Product & Process Change Notice (PCN)

PCN No: D110022

All devices in the family of D6RTB-DJD and D6RTB-HJD.

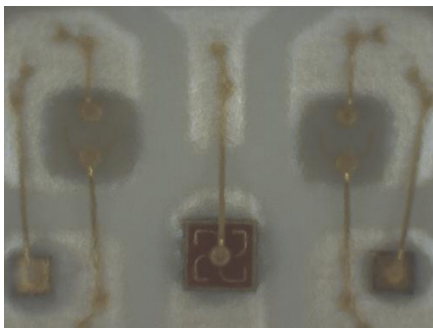
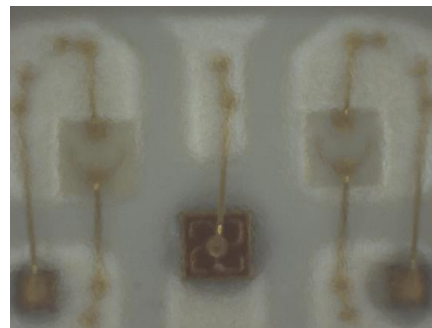
Propose to change the dark glue used for inter-connection between chip and lead-frame for the blue and true green chip to clear glue. All other material and product characteristics remain the same. The visual difference is very minimal as illustrated below.

The replacement of the dark glue to clear glue will improve the light extraction from the LED chips and improve the yield in manufacturing.

New material will be used for manufacturing beginning of Feb. 1st 2012.
